RS-09-130

LaSalle County Station, Units 1 and 2
Facility Operating License Nos. NPF-11 and NPF-18
NRC Docket Nos. 50-373 and 50-374

Subject: Additional Information Supporting Request for License Amendment Regarding Application of Alternative Source Term

ATTACHMENT 1
Response to Request for Additional Information

Drawing M-25, Sheet 5

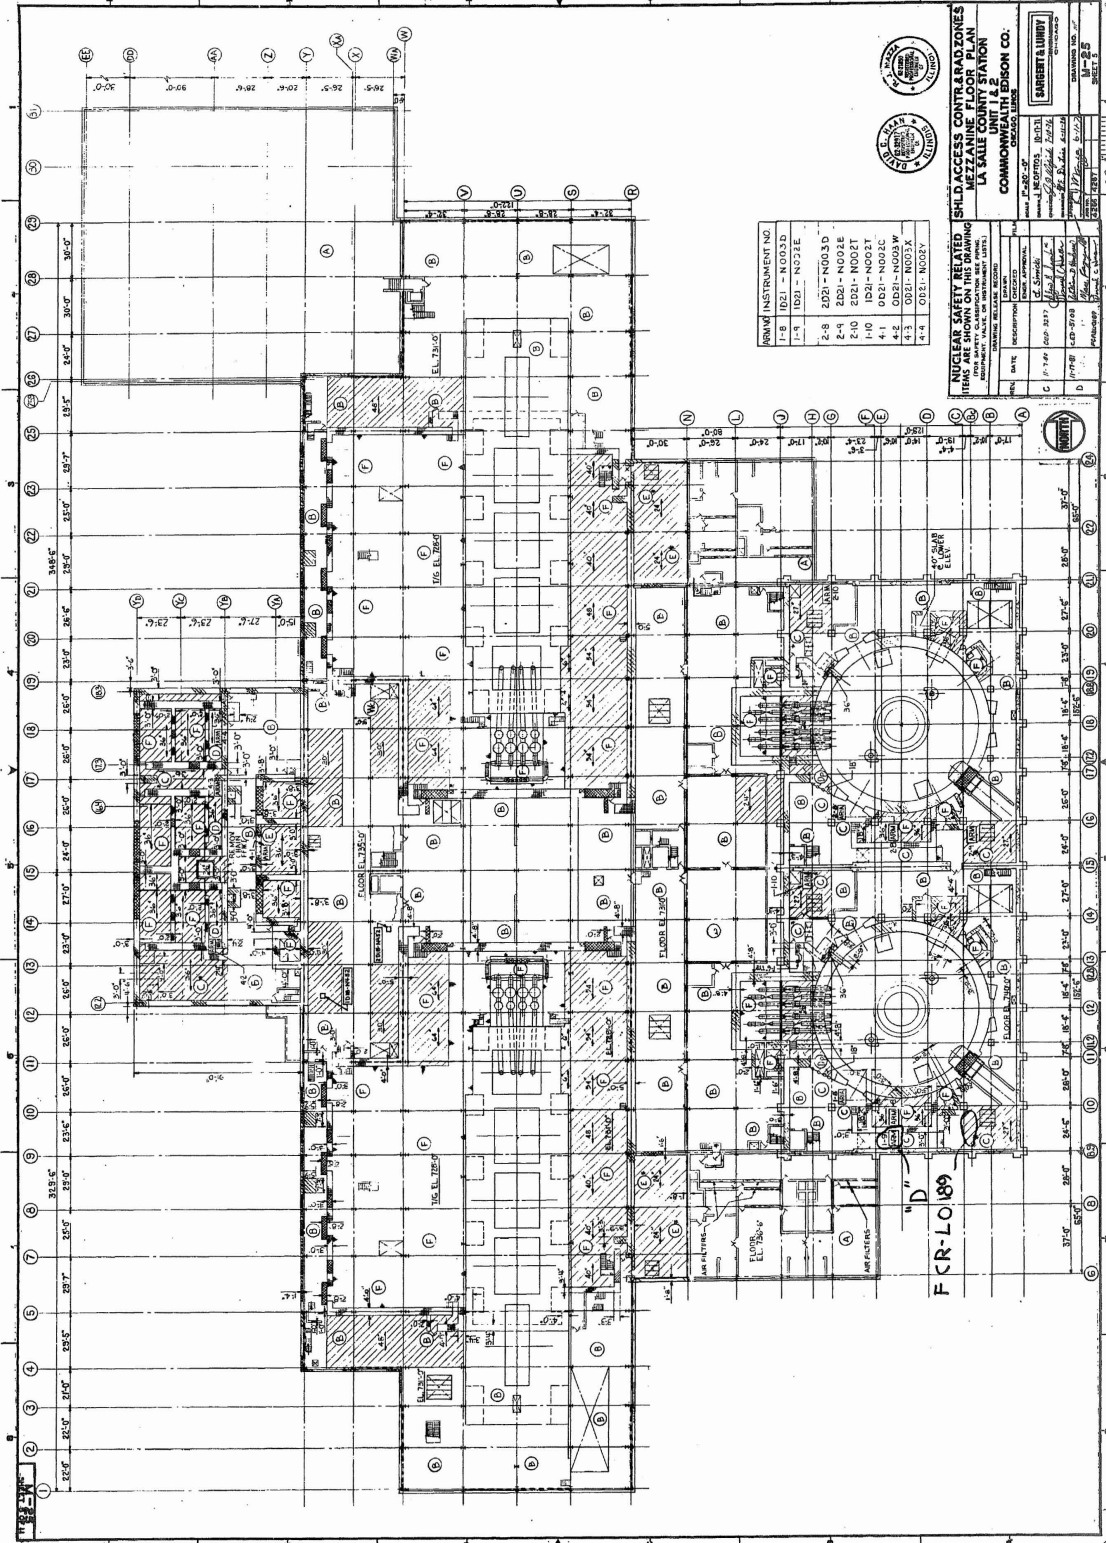
With regard to page H1 of Calculation No. L-003063, "Alternative Source Term Onsite and Offsite X/Q Values," Rev. No.1, Attachment H, which direction is true north? What is the scale of the figure? Where are the reactor building hatch access to auxiliary building roof and reactor building truck bay door release locations? How was the release point shown for the integrated leak rate test location determined to be appropriate for use in calculating the atmospheric dispersion factors (X/Q values)? Where is the assumed location for releases from the reactor building wall? Where is the control room located and why is it appropriate to assume that use of the control room air intake X/Q values as the input to the dose assessments is appropriate for unfiltered inleakage into the control room?

As shown on pages J2 and J5 of the X/Q calculation (i.e., Attachment 6 to Reference 1), true north is the same as plant north.

The drawing previously submitted to the NRC in Reference 1 (i.e., page H1 of calculation L-003063, Revision 1) includes distances along the bottom, top, and right side of the drawing. However, EGC recognizes that the actual numbers are difficult to read, and as such, a larger version of this drawing is provided in Attachment 2 for clarification.
